SEAS DEADLINE 6 RESPONSE to APPLICANTS's SUBMISSIONS
SINCE DEADLINE 5, ISH3, Action Points and ExQ3
LANDSCAPE & VISUAL and CULTURAL HERITAGE

PINS Ref: EN020026
DEADLINE 6: APRIL 13, 2026

EN020026 SEA LINK DCO – DL6: RESPONSE BY NICHOLAS BRIDGES

ZTV ANALYSIS – IP ref FA62B0DA

Figure 1. EN010077-001489-6.2.29.7 EAIN ES Figure 29.7 Onshore Substation ZTV (with landscape character)

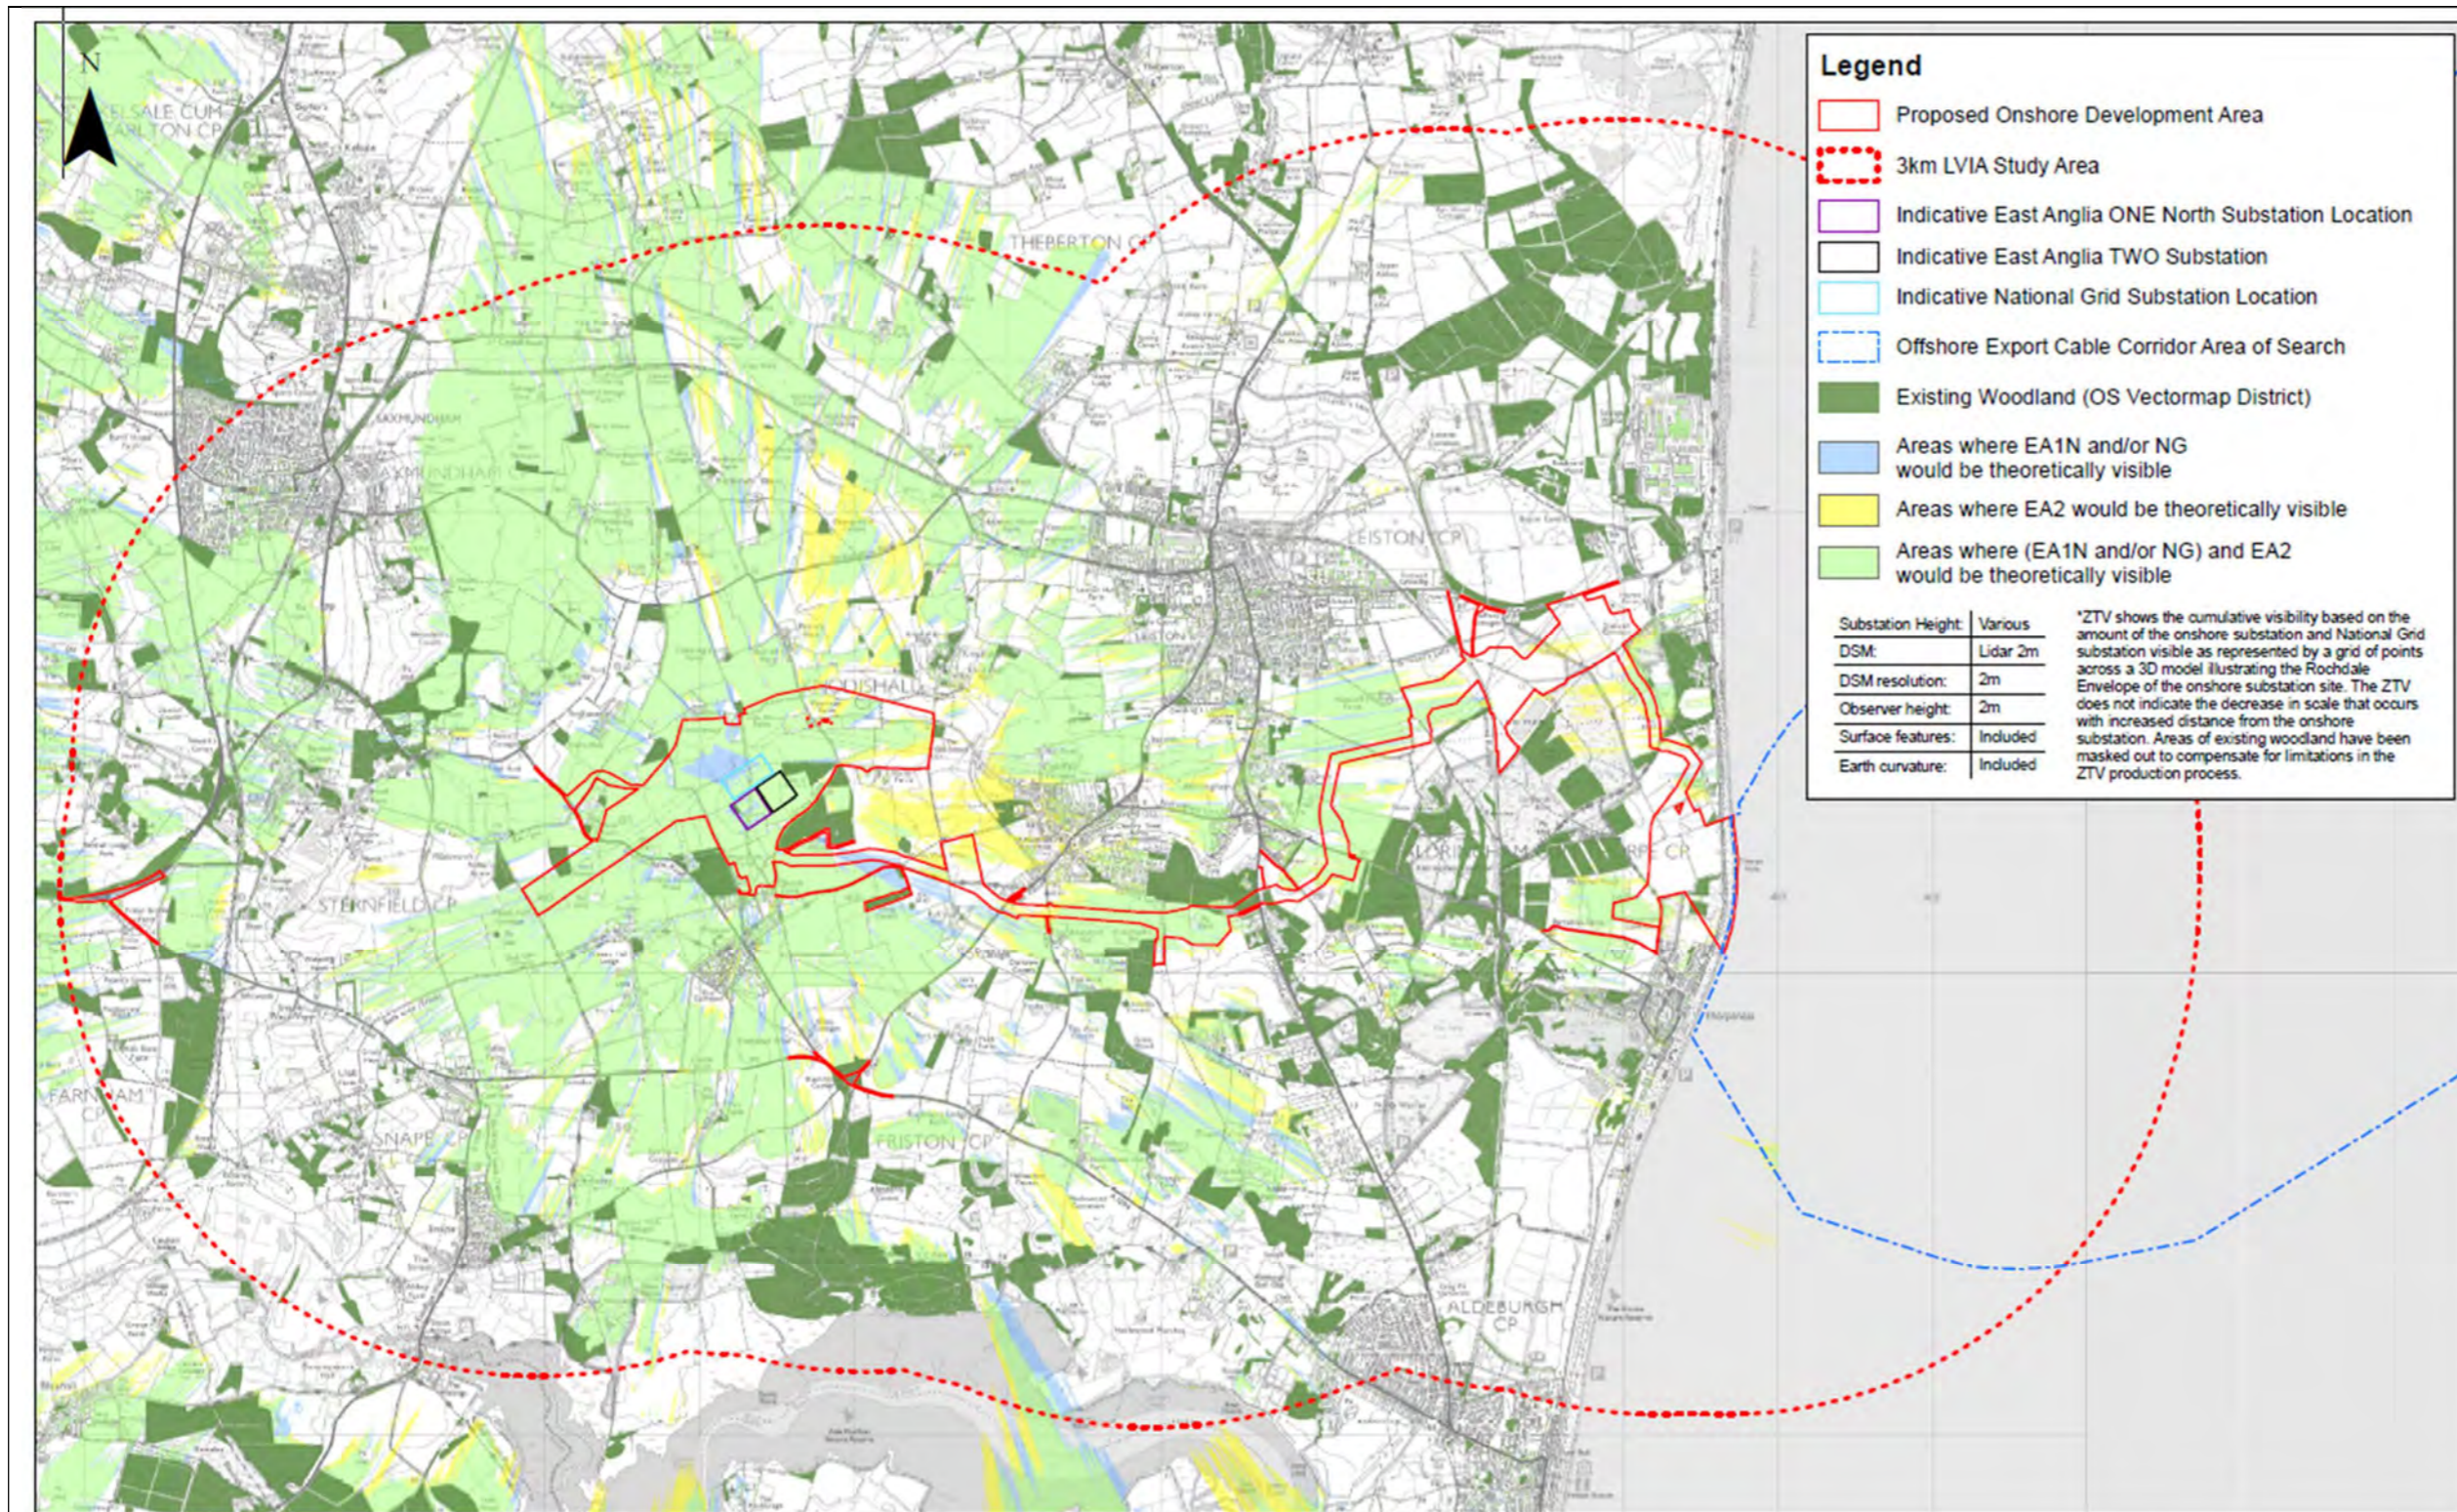
2.9. The ZTVs of the two Friston projects and Sea Link's PEIR have a similar pattern of visibility around their projects (see **Figures 1 to 11** below). Sea Link includes the National Grid substation at Friston which each of EA1N and EA2 also included. All Projects were modelled using OS contours, woodland and buildings at a generic height. Observer heights were a little higher for EA1N and EA2. The two Friston substations used the same parameter model as Sea Link.

2.17. The applicant does not seem aware of the EA1N and EA2 ZTV plans (**Figures 1, 2 and 3** below) which show that those developments would be visible. Nor the Sea Link PEIR likewise. Visibility from the top of the church tower is not relevant as the public have no access nor is it important as a private viewing point, unlike the Martello Tower for which this use was its primary function.
